Structural Clarification Item

Project: StruXure - McArthur
8609 SE 78th St
Mercer Island, WA 98040

Project Number: 22-07-090

Re: Building Jurisdiction Comments

ASSUMED HOUSE PLAN & DIMENSIONS

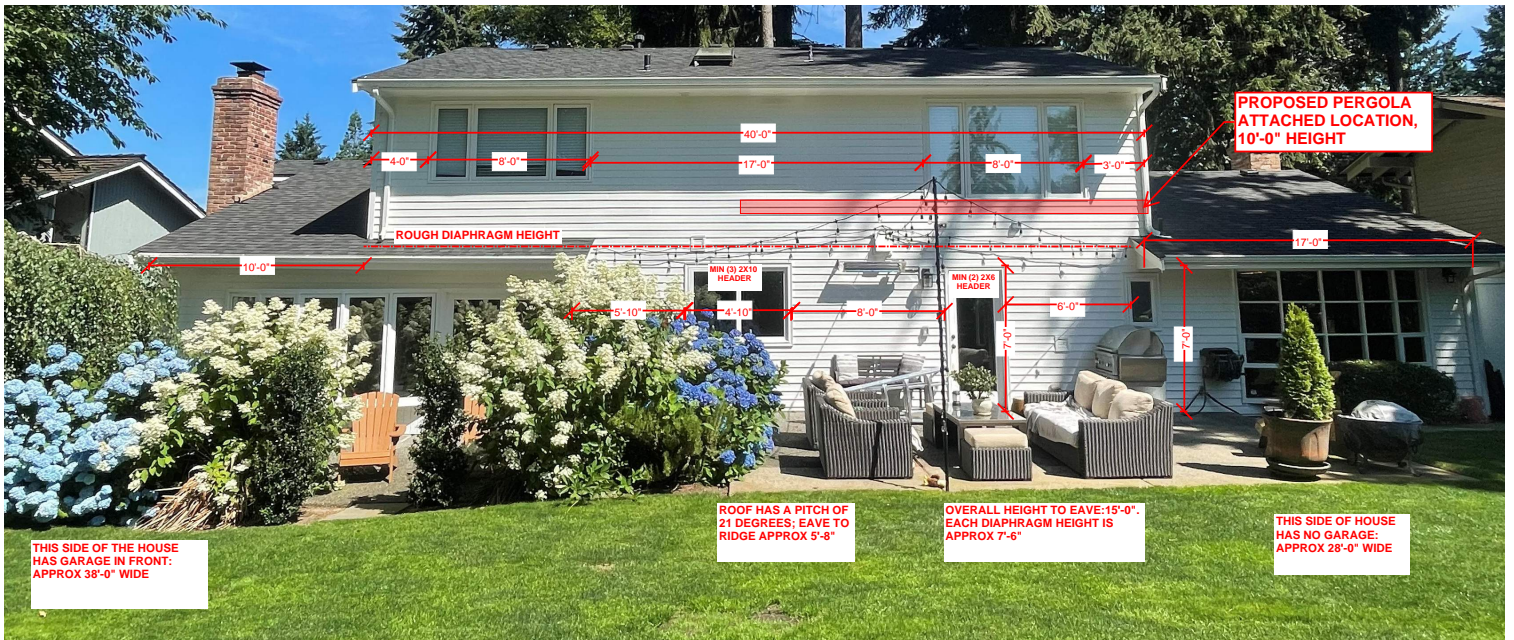
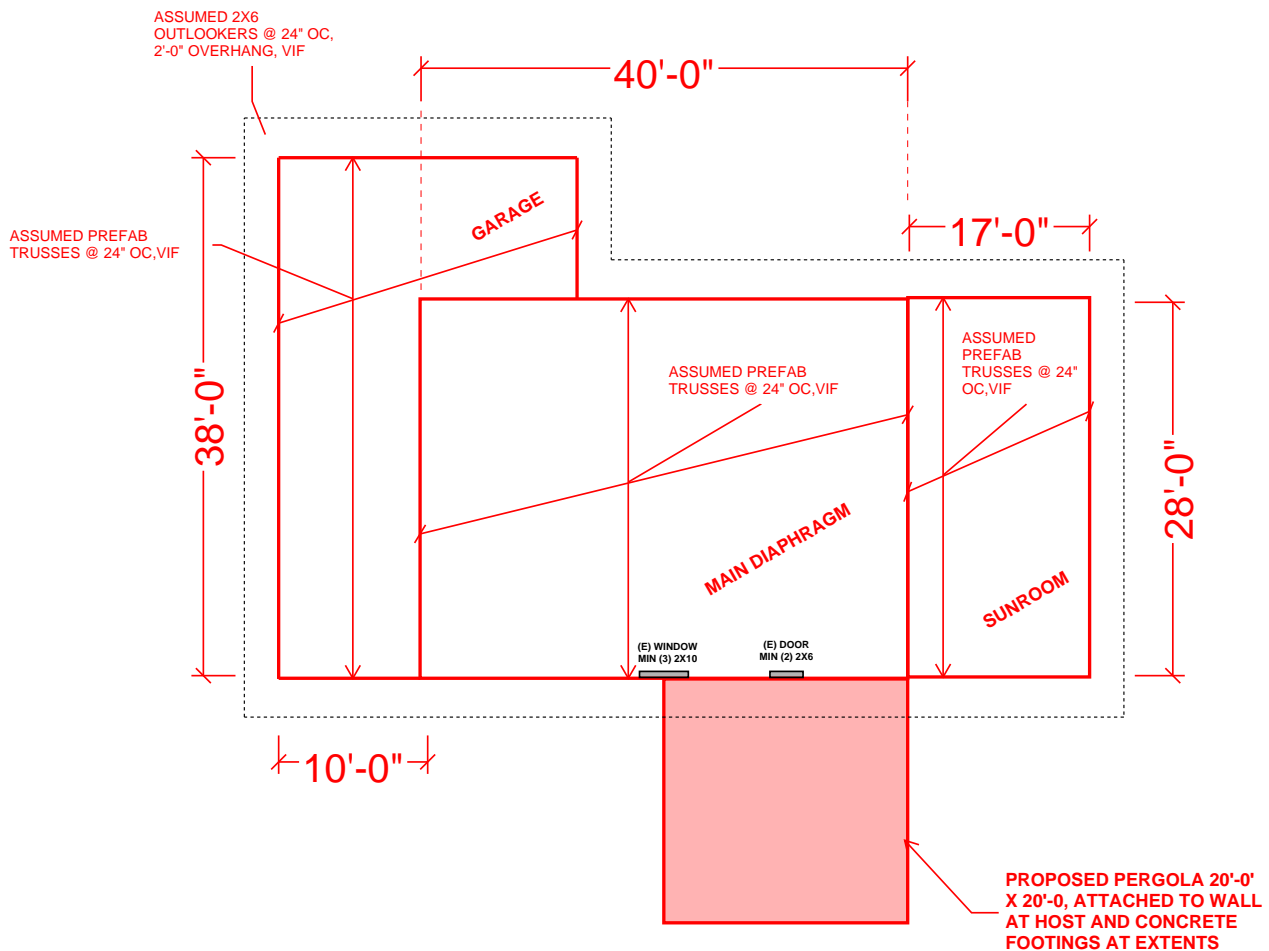
- 3.) EEPC has analyzed the existing structure for the additional loading of the host structure.
 3. *An analysis of host structure applied loads provide justification that house structure can properly handle design load referenced on last page of structural package.*

Building Plan Review ... July 21
As analysis of Host structure applied loads provide justification that Host structure can properly handle design load referenced on last page of structural packet.

$w_{D1} := 28 \text{ ft}$	Width of House Diaphragm
$trib_w := \frac{w_{D1}}{2} = 14 \text{ ft}$	Tributary width of house
$w_{ext} := trib_w \cdot (DL_r + SL + DL_f) = 882 \text{ plf}$	Existing loading on Wall Line
$w_{new} := trib_p \cdot (DL_p + SL) = 350 \text{ plf}$	New Imposed Vertical Loading due to Pergola

$$Result_1 := \text{if} (F_{plf} \leq 0.1 \cdot WL_1, \text{"Okay, w/i 10\% Allowable"}, \text{"NG"}) = \text{"Okay, w/i 10\% Allowable"}$$

A 307

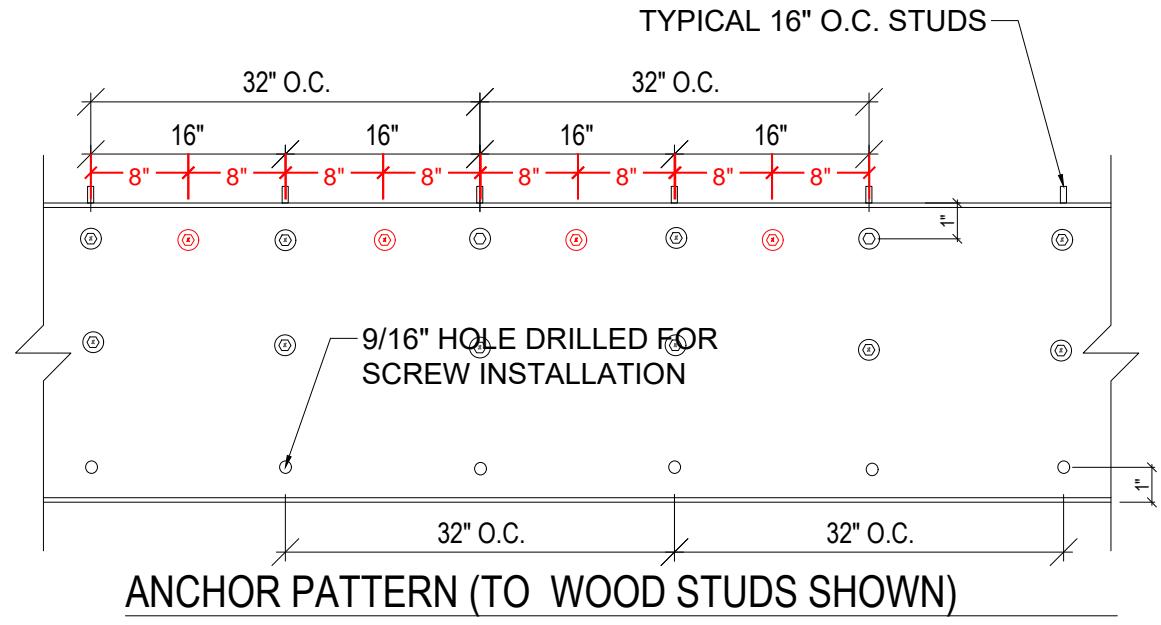
- 1.) Eclipse Engineering, P.C. (EEPC), has provided fastener calculations for a 2" distance between blocking and the screw head.
 1. *Provide Max distance between blocking and head of screw to be considered in design*

- 2.) EEPC has provided calculations for a new ledger/blocking with a minimum thickness of 1-1/2".
 2. *Verify that there is a 3" of embed depth in ledger of the house to comply w/the detail and designed and calculated.*

- 4.) EEPC determined new blocking must be installed between host studs to provide ledger connections at the proposed pergola height of 10'-0".
 4. *Provide actual height of the attachment detail to engage with blocking provided in detail A/307. Concern of existing ledger or bottom plate to actually engage.*

PAGE 5
Building Plan Review ... July 21
Provide actual height of the attachment detail to engage with blocking provided in detail A207. Concern of existing ledger or bottom plate to actually engage.
If for instance it was a 10' plate or 8' plate.

PAGE 16
Building Plan Review ... July 21
Provide Max distance between blocking and head of screw to be considered in design.

Building Plan Review ... July 21
Verify that there is 3" of embed depth in ledger of the house to comply with the detail as designed and calculated.
A standard house ledger would not have enough depth.

**MUST INSTALL NEW
 BLOCKING
 BETWEEN STUDS
 CONNECT
 PERGOLA TO HOST
 STRUCTURE AND
 BLKG W/ (2)
 SDS25134 @ MAX
 16" OC BTM & (1)
 SDS25134 @ 8" OC
 TOP**
